PROJECT: 146054.000 JE Muchert SA1 DATE SENT: 5/30/2019
 146054.000 RETURN BY:
 SUBJECT: 13 35 13 - 002 Rammed Earth SUBMITTAL ID: 13 35 13-002
 Wall Shops
 TYPE: Submittal TRANSMITTAL ID: 00323
 PURPOSE: For Review VIA: Info Exchange
 SPEC SECTION: 13 30 00

Dallas Parks & Rec.
Sims General Building

Rammed Wall 3/32" = 1'

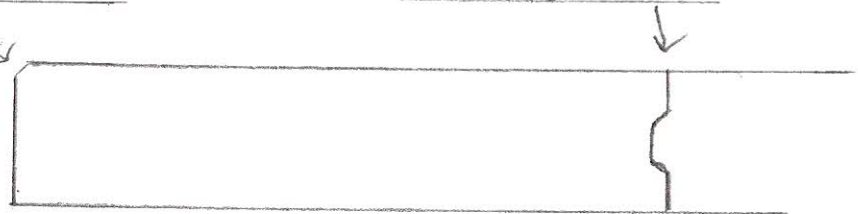
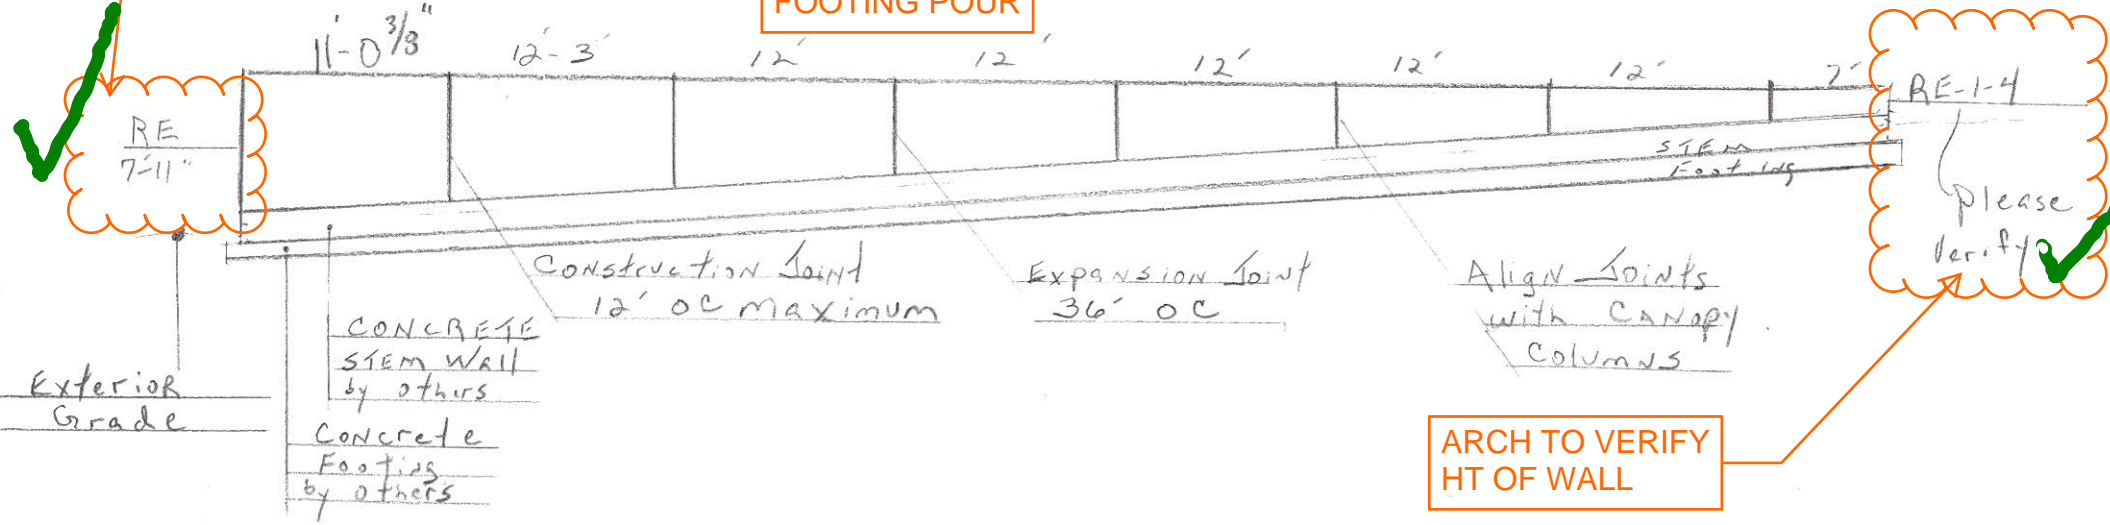
ARCH TO VERIFY
HT OF WALL

DOWELS TO BE
PLACED WITH
FOOTING POUR

ARCH TO VERIFY
HT OF WALL
